Comments to 691 Building Design Review Pre-App

I am Dale Bates, the neighbor to the south of the proposed project on Lot 2 Block 54 Ketchum Townsite. I am also a retired architect who has practiced in Ketchum for over 45 years. I'd like to bring to your attention some issues with the design and the submittal package for this project.

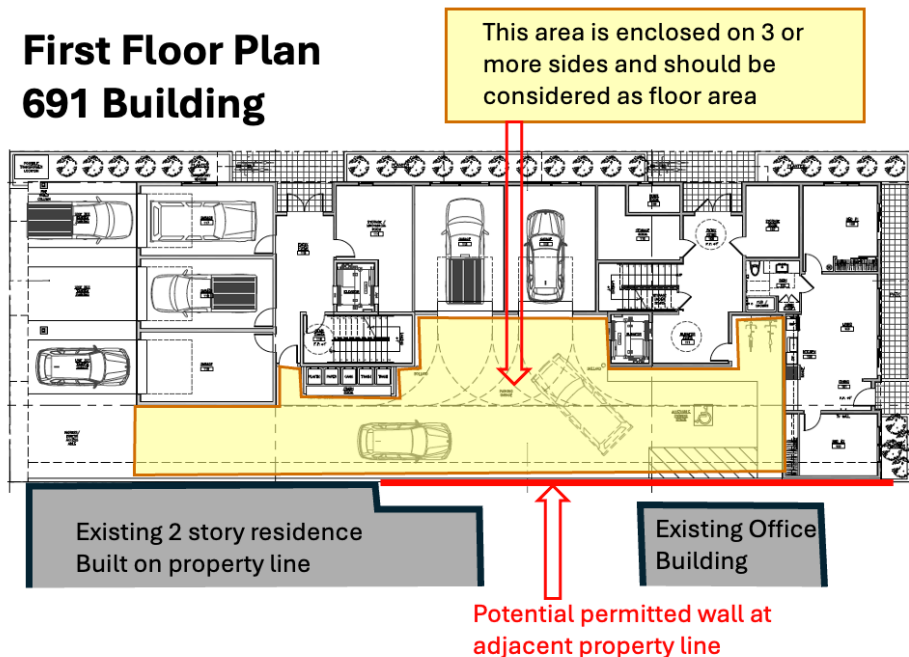
1.1 The design of the first floor places a 125' long driveway with open parking, garage back out, and trash area a mere 4" from an interior lot line to an adjacent property with only a perforated metal screen. This creates an undo impact on the adjacent property. It creates a potential fire hazard, noise impact, exhaust pollution and vehicle danger. This is a significant Environmental Impact that should be addressed.

The first floor area of driveway and parking should be considered part of the gross floor area and calculated in the FAR. It should be included because it is enclosed on 3 or more sides-2 sides by the building and it should be considered closed on the south side because it is immediately adjacent to private property that can have wall built at the property line. This side should not be considered open. See Diagram:

The application does not include a F.A.R. calculation, but they submit the
Lot Area =8,241sqft Gross floor area =15,998 sqft F.A.R. =1.94
However if the driveway and parking on the first floor is included in the floor area as
required by code an additional 2,130sqft must be added to the building area bring the
Gross Floor area 18,130 sqft. = 2.2 F.A.R.
